**PLANNING UNIT REPORT
DEPARTMENT OF PLANNING AND DEVELOPMENT
of June 13, 2006**

RE: ID# 03933: Approval of the final plat of "Badger Mill Creek"

DATE: June 8, 2006
TO: Plan Commission
FROM: Larry D. Nelson, P.E., City Engineer
SUBJECT: Badger Mill Creek - 3120-3160 Jeffy Trail Plat

Re: Badger Mill Creek Final Plat Phase One

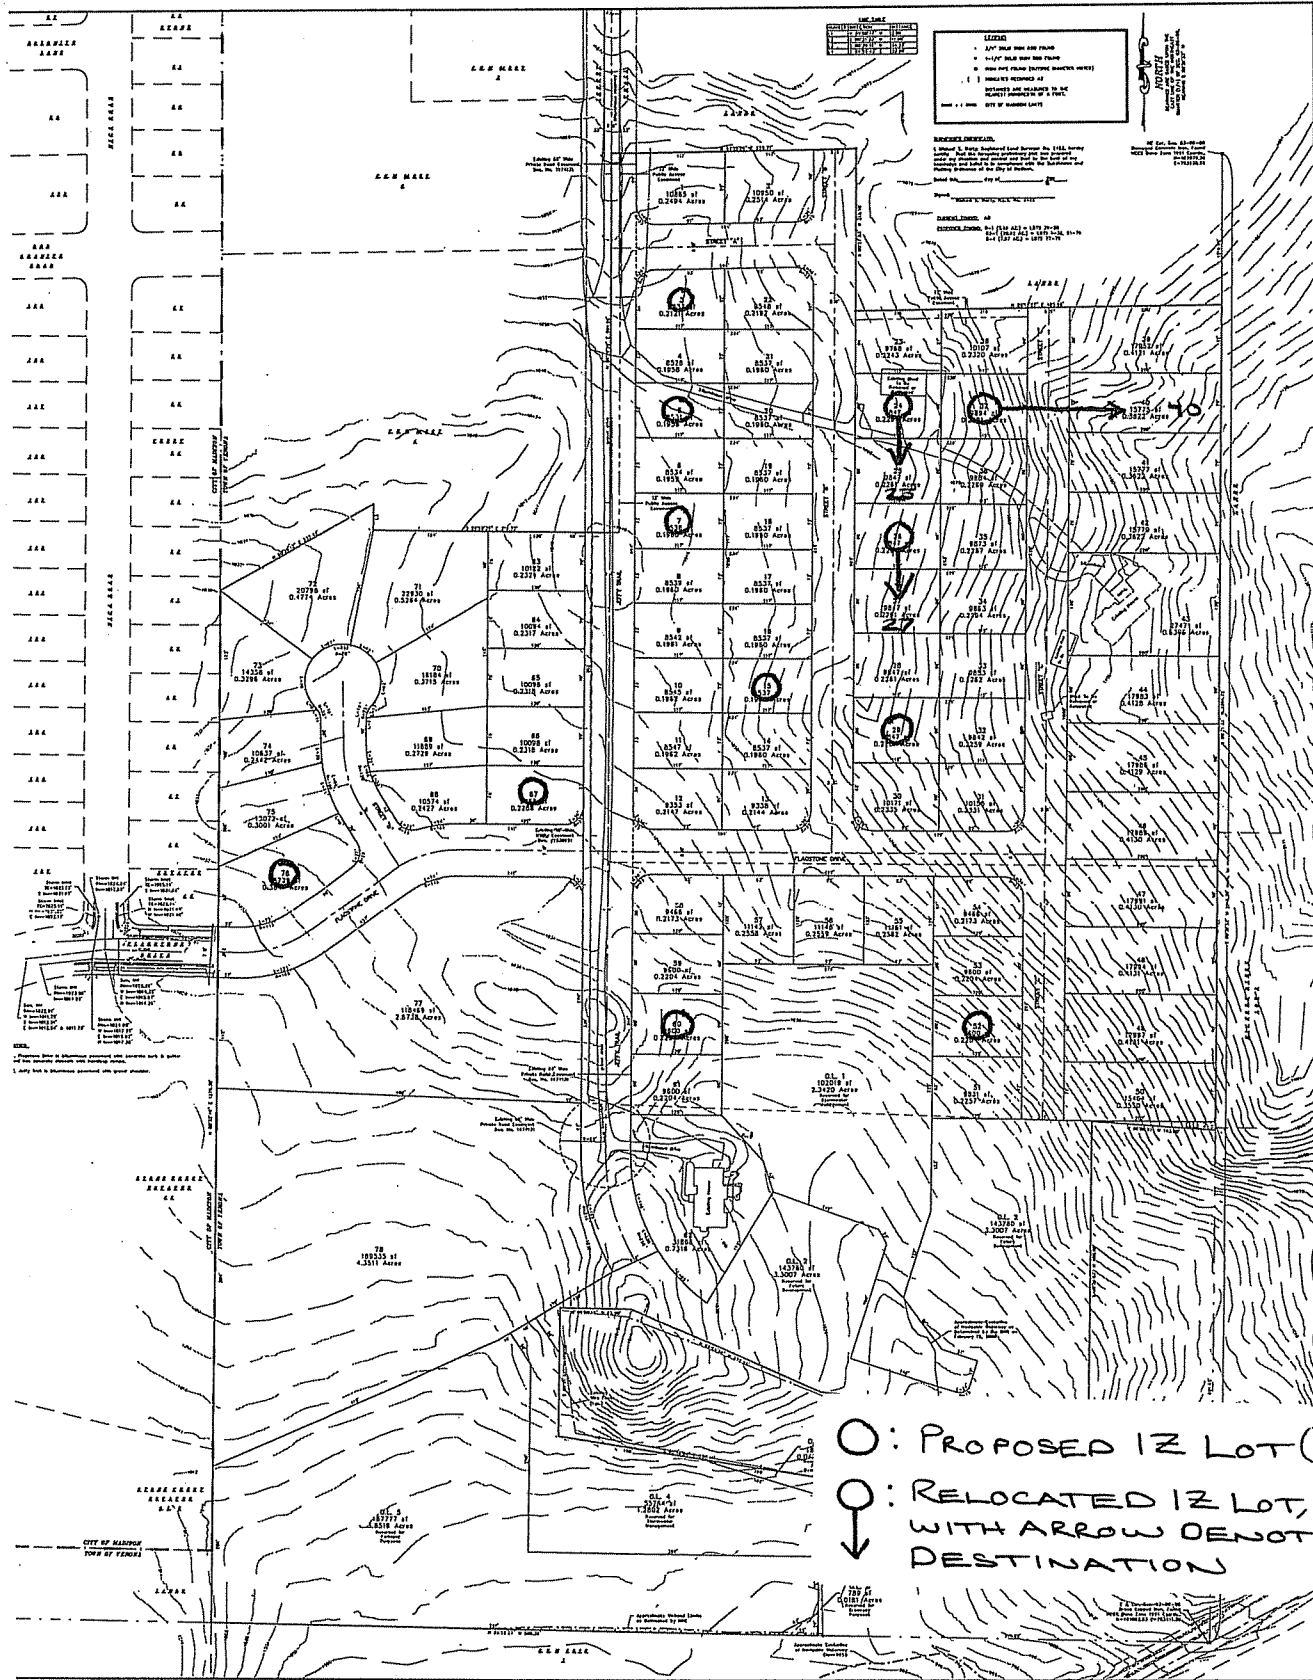
With respect to the first requested amendment, the developer has realized that he gave an option to the underlying land owner to purchase back lot 24 of the preliminary plat when that lot is final platted. Lot 24 of the preliminary plat, as well as lot 26 of the preliminary plat, were designated as IZ lots. The developers are requesting an administrative amendment to move the IZ designations from lots 24 and 26 of the preliminary plat, to lots 25 and 27 of the preliminary plat.

The second change involves lots 39-50 of the preliminary plat, those being the large lots east of Trevor Way. As you recall, the IZ plan submitted by the developer did not designate any of those lots as IZ lots. The Plan Commission, as part of the IZ approval of the

preliminary plat for Badger Mill Creek required the identification of an IZ lot(s) among lots 39-50 (of the preliminary plat) if the IZ ordinance were not amended to allow exclusion of those lots.

The main issue before the Plan Commission, which it did not really deal with at the meeting concerning the preliminary plat for Badger Mill Creek, was whether the Plan Commission has the authority to exclude certain lots from being designated as IZ lots. It is our position that the Plan Commission, in exercising its discretion, does have that authority. The concept of distribution and dispensation is found in Section (g) 6. of the Ordinance which provides "The exclusionary dwelling unit shall be disbursed throughout the development. . ." Neither the Ordinance nor the policies and protocols further define what constitutes "distribution." We would submit to the Plan Commission that what the Ordinance was meant to do was to prevent a clustering of the IZ units that would make the IZ units readily identifiable and thereby stigmatizing the owners of the IZ units. We would submit that the developer's IZ plan does not provide for any such clustering and that the requirement to designate any of lots 39-50 of the preliminary plat are simply undue hardship upon the developer with no countervailing public benefit. We would therefore ask the Plan Commission and Common Council for relief from the requirement of including an IZ lot among lots 39-50 of the preliminary plat. Failing that, we would propose a change in the IZ designation from lot 37 of the preliminary plat to lot 40 of the preliminary plat.
